2017 PUD Amendment The Village at Clark Brook

Old Dover Road
Rochester, NH

December 12, 2017
Revised: April 19, 2018

Proposed Changes to 2012 Notice of Decision

PUD LAYOUT CONCEPT

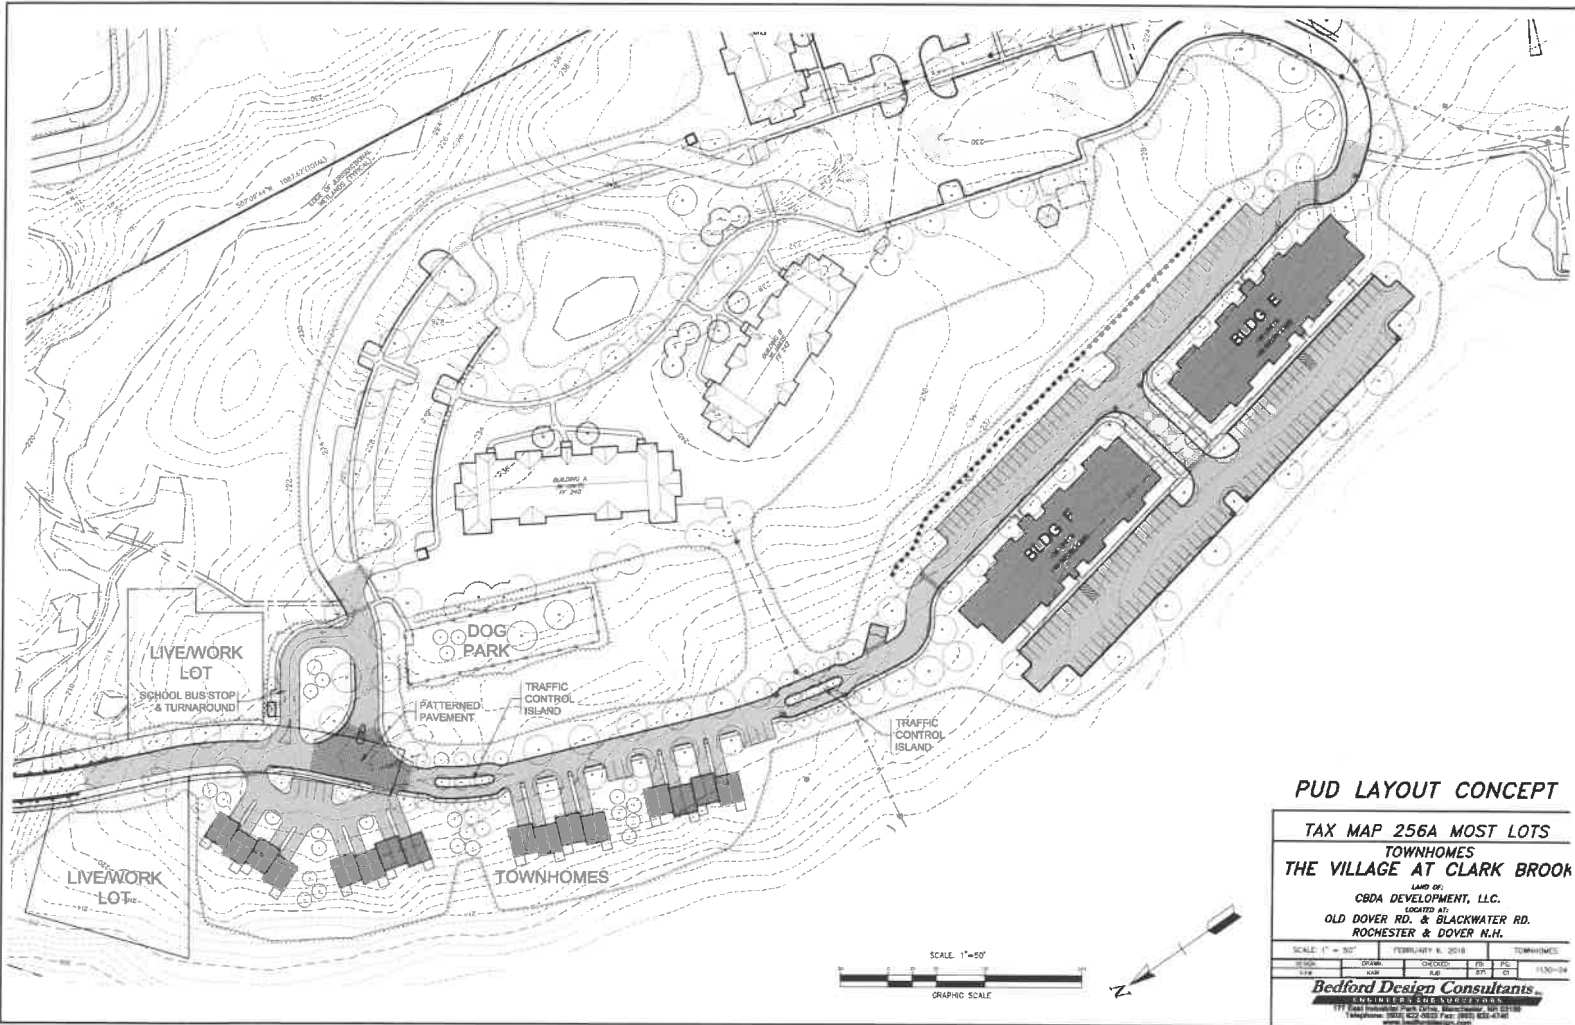
- Athenian Way up to Asteria Lane will remain a public street. The rest of Athenian Way will become a private drive. This will reduce the amount of road of area to be plowed by the City.
- The Single Family lots on Athenian Way will be removed.
- The Live/Work Units will remain and two more will be added.
- 16 Townhomes will be added to the mix of unit types for the PUD.
- Three Constitution Way lots will be consolidated.
- The Proposed changes will increase the amount of green space for the PUD
- The PUD package city cross section will be redesigned.
- The number of units allowed will be increased to 275(from 262) but the number of bedrooms will remain at a maximum of 571.
